UNITED STATES PATENT AND TRADEMARK OFFICE

APPLICATION NO.	FILING DATE	FIRST NAMED INVENTOR	ATTORNEY DOCKET NO.	CONFIRMATION NO.
10/748,047	12/30/2003	Roger Adrien Boutin	065517.00072	6747

Office Action Summary	Application No. 10/748,047	Applicant(s) BOUTIN, ROGER ADRIEN	
	Examiner Jerry Redman	Art Unit 3634

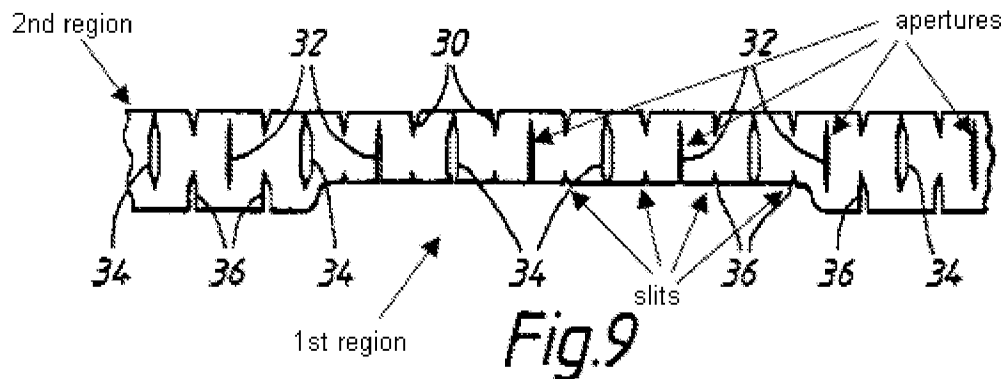
Claims 1-3, 5-10, 12-17, 19-21, and 23-27 are rejected under 35 U.S.C. 102(b) as being anticipated by Bright et al. (5,752,345). As shown in Figures 9 or 10 (depending on how the “width” is defined, i.e., in the flattened state or U-shape), Bright et al. (5,752,345) disclose a weather strip (12) in combination with a motor vehicle (see figure 1) comprising a steel metal carrier (22) having a U-shaped cross-section (sealing flanges each side of the weather strip) having a first region having a first flexibility and repeating pattern along a longitudinal length (see figure below) and a second region having a second flexibility and a second repeating pattern along the longitudinal length (see figure below), and an elastomeric material (14) disposed about the metal carrier (22) and including a tubular/hollow sealing feature (16) extending from the weather strip (12). Bright et al. (5,752,345) further disclose the first region having a plurality of slits (36) disposed along the carrier (22). Bright et al. (5,752,345) still further disclose the second region having a plurality of apertures (32) centrally located along the carrier (22)

(see figure below). Bright et al. (7,752,345) still further disclose the first region and second region to have distinct flexibilities (column 4, lines 50-60). Since the U-shaped carrier, in its sealing function, has the same width throughout, both regions have the “same width” throughout. [note: the apertures (32) are spaced from each other at a first distance and the slits (34) are spaced from one another a second distance different from that of the first distance.] Bright et al. (5,752,345) still further discloses the first and second regions to each have a distinct common configuration with the configuration of each region being different based on that the second region having slits that are longer on the bottom than the slits in the first region. Therefore, in each region, the repeating pattern is different from one another.
